Review of Draft Report on LOCA Frequency Estimates by Expert Elicitation

**Corwin L. Atwood, Statwood Consulting
November 2, 2004**

Figure A.4. Results for Category 6 LOCAs at age 25 years, with no aggregation.

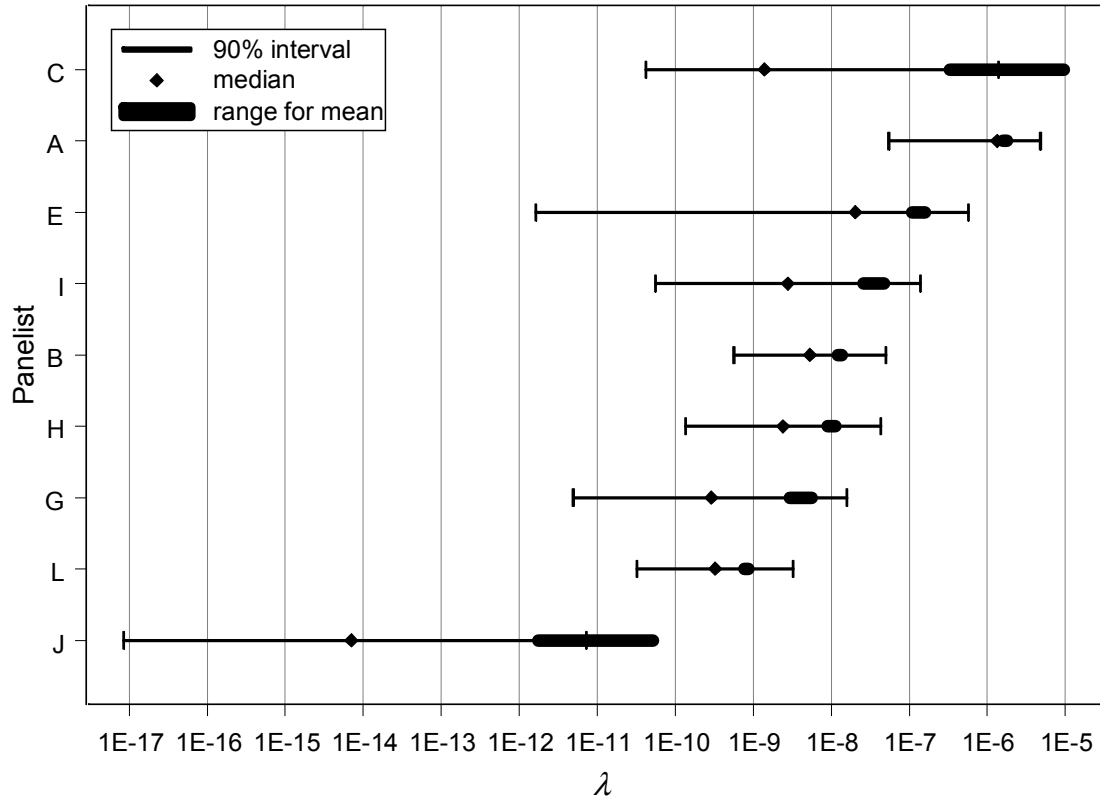
The Table shows in bold face all the cases for which the mean exceeds the other seven or eight means by a factor of 10 or more. These bold-face cases are the ones where it is most critical to show the uncertainty in the mean. For those cases, the entire range between the (possibly truncated) lognormal mean and the log-triangular mean could be displayed when presenting the uncertainty in the means. Figure A.4 is an example where this is done.

It can be seen that the panelists with the longest intervals, that is, the largest error factors, have the most uncertainty in the means, as discussed in Section 3. Clearly, panelist J is an outlier at the low end. At the high end, panelist C may be considered an outlier because of the large mean and extreme skewness, or panelist A may be considered an outlier because of the large median. Identification of the outliers, especially on the right, is somewhat subjective.
